Sun Fire™ 6800/4810/4800/ 3800 Systems Product Notes

Part No.: 806-7217-10
August 2001, Revision A

Software Product Notes

FIGURE 1 Sun Fire 3800 System Serial Number Location—Rear View

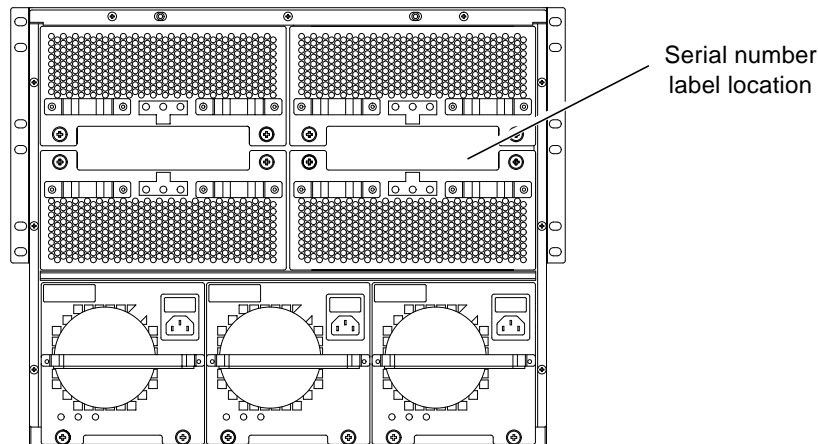
- The serial number label location for the Sun Fire 3800 System (Appendix B-5) was changed after the *Sun Fire 6800/4810/4800/3800 Systems Service Manual* went to press. FIGURE 1 shows the correct serial number label location.
